Access Compliance Report

Public Rights-of-Way

(Curb Ramps)

Intersection ID: 15675	Main Street: EAST_BV	Cross Street: LOMBARDY_CR	Location: W
ADA ID: 4E09500C8055	Ramp Type: PerpDiag	Initial Pass/Fail: Fail	Overall Compliance: No
Severity Score: 13.75			
Codes/Mitigation Info/Possible Solution		Field Measurements/Component Compliance

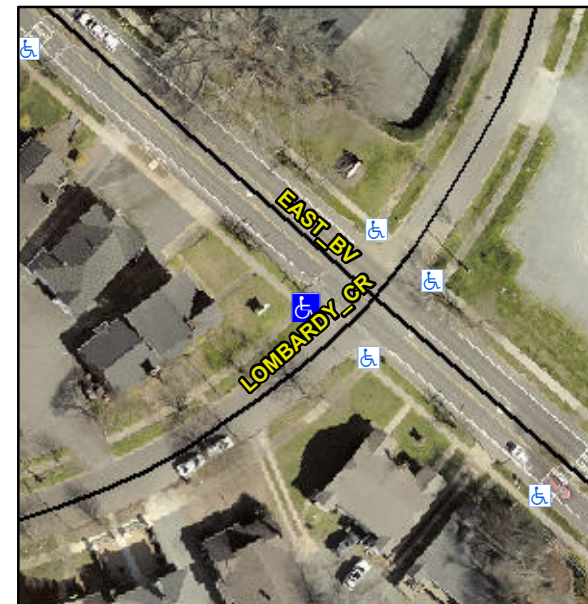
Not Found, R304.2.2, R304.5.3

Compliance	Description	Data	Compliance	Description	Data
N/A	Ramp Length (in)	115.0	No	Ramp Slope (%)	10.0
Yes	Ramp Width (in)	48.0	No	Ramp XSlope (%)	2.9
N/A	Flare Type LT	N/A	N/A	Flare Type RT	N/A
N/A	Flare Slope LT (%)	N/A	N/A	Flare Slope RT (%)	N/A
N/A	Flare Traversable LT?	N/A	N/A	Flare Traversable RT?	N/A
N/A	Landing Length (in)	N/A	N/A	DWS Provided?	N/A
N/A	Landing Width (in)	N/A	N/A	DWS Contrast?	N/A
N/A	Landing Slope (%)	N/A	N/A	DWS Length (in)	N/A
N/A	Landing X Slope (%)	N/A	N/A	DWS Full Width?	N/A
N/A	Landing Curb? (Y/N)	N/A	N/A	DWS Offset (in)	N/A
N/A	Shared Landing?	N/A			
N/A	Gutter Ponding?	N/A	N/A	Gutter Slope (%)	N/A
N/A	Gutter Lip Ht (in)	N/A	N/A	Gutter X Slope (%)	N/A
N/A	Painted X Walk1?	No	N/A	Painted X Walk2?	No
	X Walk 1 Direction	To SE		X Walk 2 Direction	To NE
N/A	X Walk 1 Width (in)	N/A	N/A	X Walk 2 Width (in)	N/A
	X Walk 1 Slope (%)	1.7		X Walk 2 Slope (%)	3.8
	X Walk 1 X Slope (%)	0.2		X Walk 2 X Slope (%)	0.2

Remove & Replace Curb Ramp With Two New Directional Ramps or Equivalent.
